STATE OF NORTH CAROLINA
DEPARTMENT OF TRANSPORTATION

Subject: Request for Modification of Section 404 Individual Permit and Section 401 Water Quality Certification for the U-2579B Section of the Winston-Salem Northern Beltway, from US 158 to I-40 Business/US 421, Forsyth County, Division 9, WBS 34839.2.10

The North Carolina Department of Transportation (NCDOT) requests a Permit Modification for the Winston -Salem Northern Beltway Eastern Section from US 158 to I-40, B Section of the U-2579 TIP. This project is currently under construction.

PERMIT DRAWING MODIFICATION FOR SITE 23 AND 28

OCTOBER 1, 2019 PERMIT DRAWING SHEET 5 OF 10

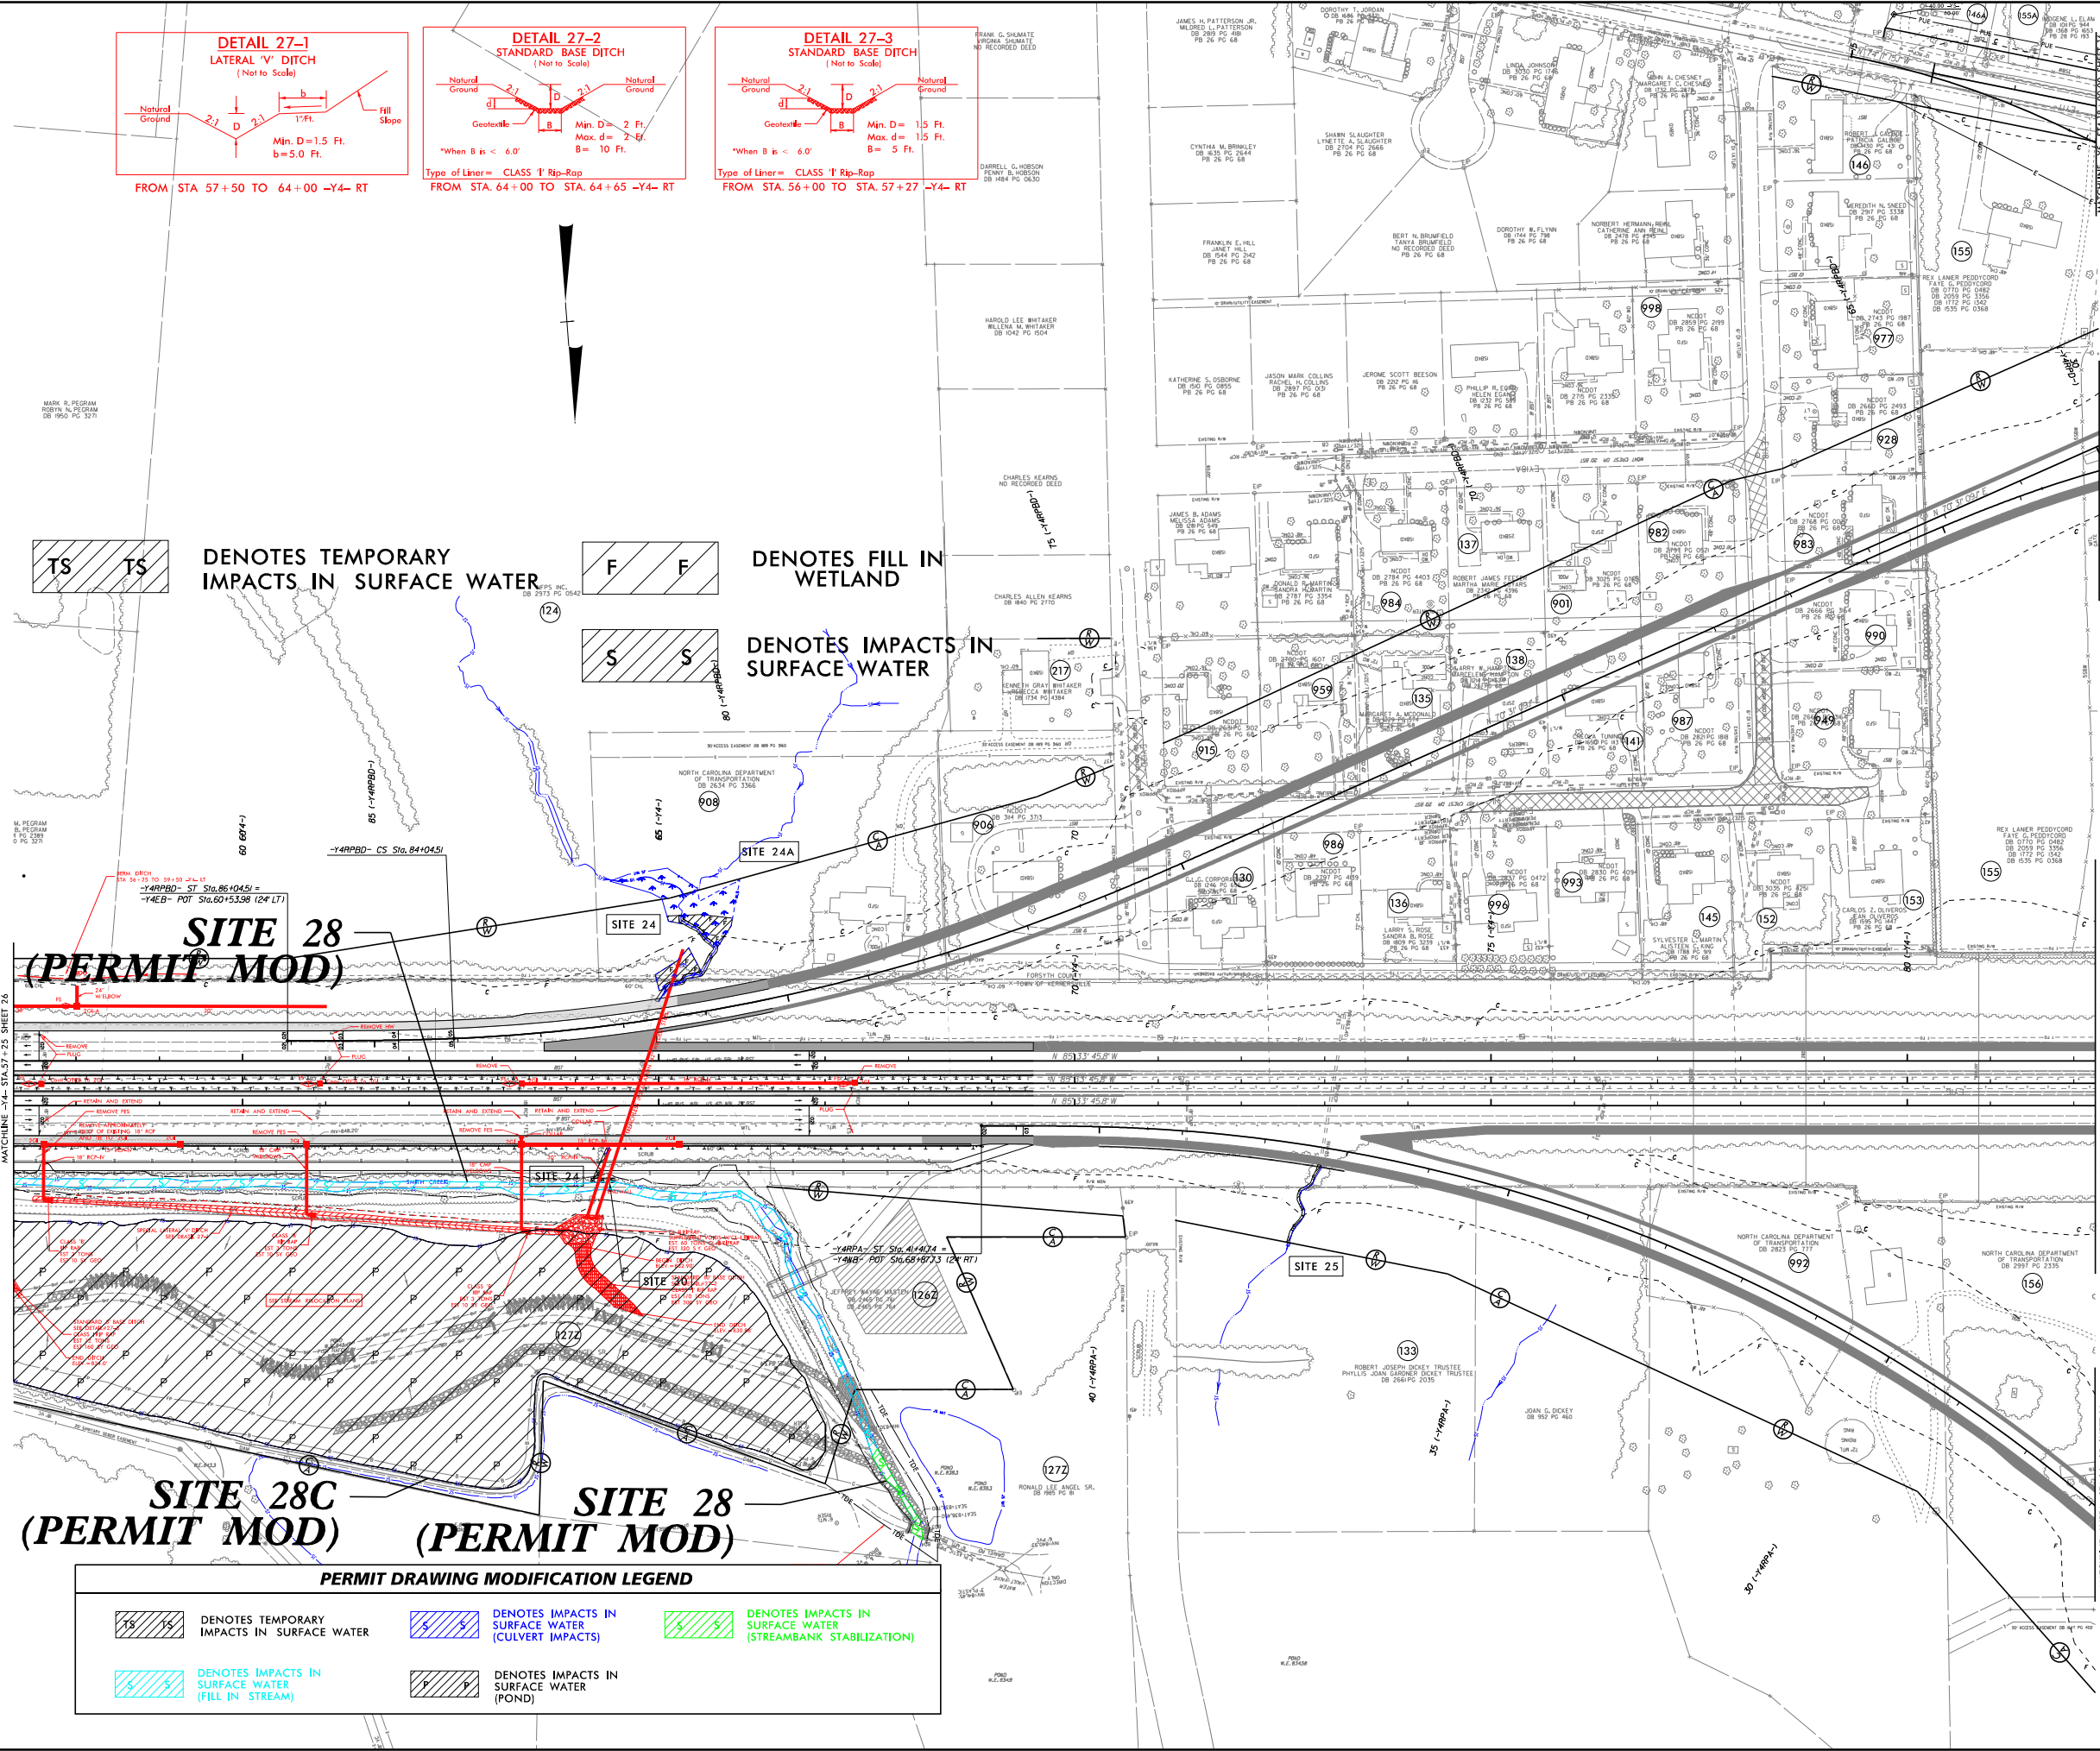
PERMIT DRAWING MODIFICATION FOR SITE 23 AND 28

SITE 28 (PERMIT MOD)

SITE 28C (PERMIT MOD)

SITE 24 (PERMIT MOD)

OCTOBER 1, 2019 PERMIT DRAWING SHEET 6 OF 10

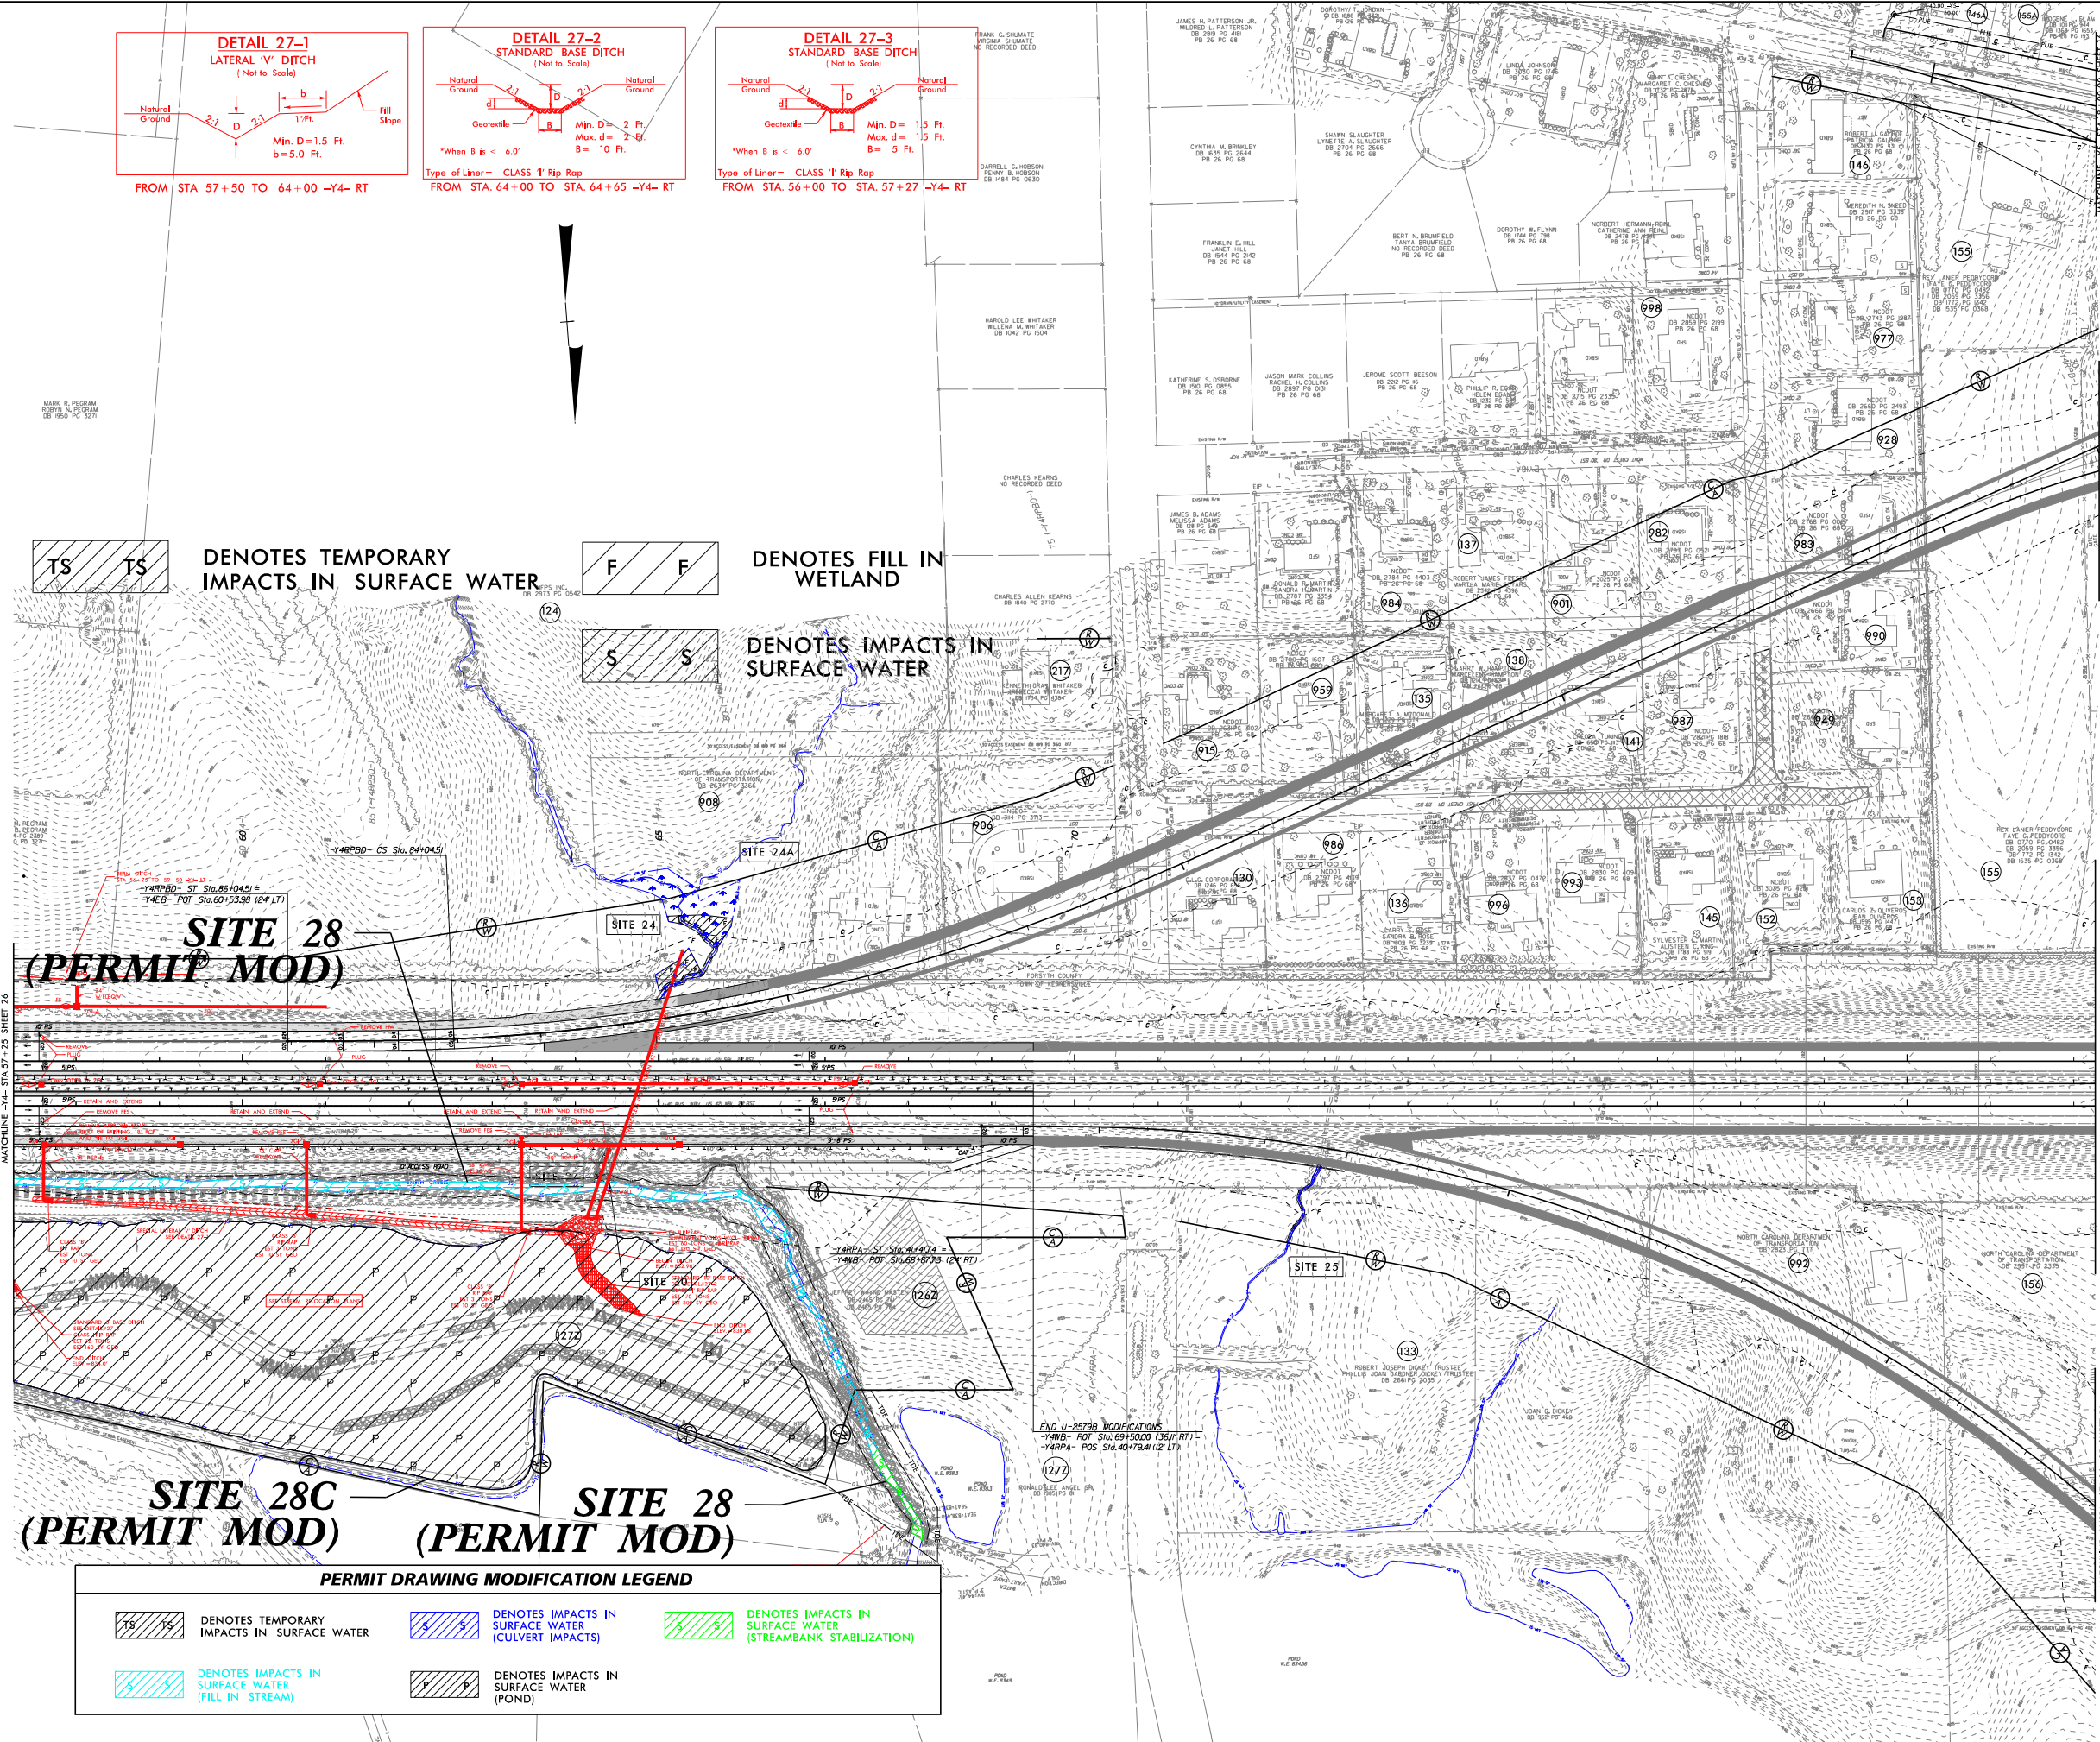
PERMIT DRAWING MODIFICATION FOR SITE 23 AND 28

DETAIL #2 OUTLET CHANNEL IMPROVEMENTS

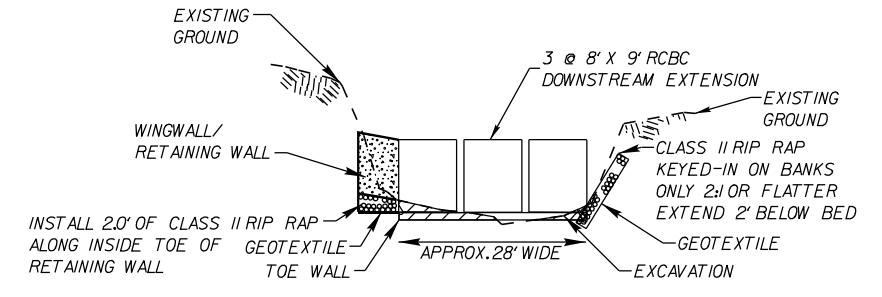
DETAIL #1 INLET CHANNEL IMPROVEMENTS

STA. 44 + 70 -Y4- LT

STA. 46 + 50 -Y4- RT
